APICAL INDUSTRIES, INC.
dba DART AEROSPACE

ENGINEERING CHANGE NOTICE NO.

06749

DWG TITLE: A119Kx LIFERAFT RESERVOIR FAIRING

SHEET 2, SECTION C2 WAS:

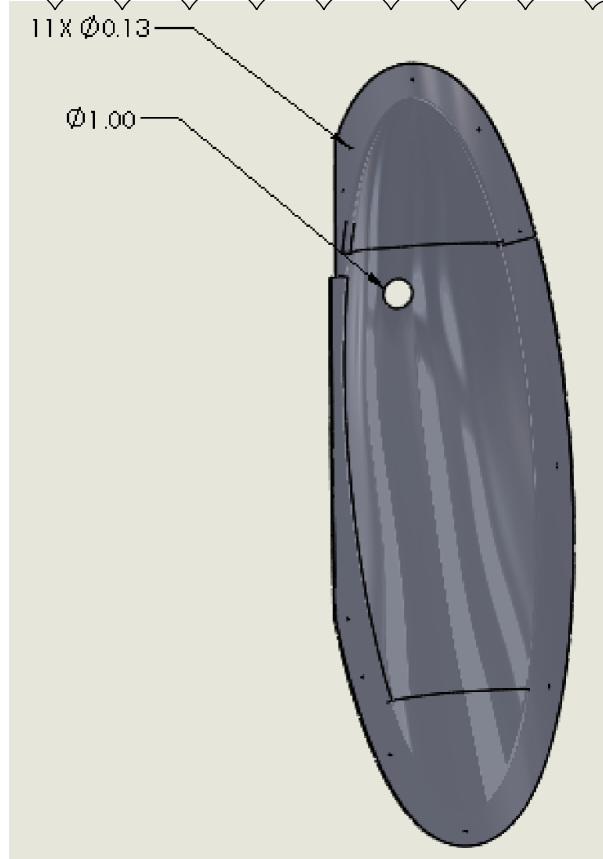
REASON: UPDATED VIEW SHEET 2, SECTION C2. UPDATED DELTA NOTES 6 AND 7. ADDED VIEWS SHEET 2, SECTION B1 AND B3. ADDED DELTA NOTE 11.

SHEET 1, SECTION B1 WAS:

- 6. BOND F/N 2 & F/N 3 TO INSIDE SURFACE OF FAIRING AND SEAL WITH F/N 4
- 7. COVER OUTBOARD SIDE OF F/N 1 WITH $\phi 2.0$ OF PROTECTIVE TAPE F/N 5
- 9. MATERIAL P/N 601.1422 CLEAR TUFFAK AM, .030 THK
- 10. MATERIAL P/N 600.1028, VENDOR P/N 3M8672

SHEET 2, SECTION A2 WAS:
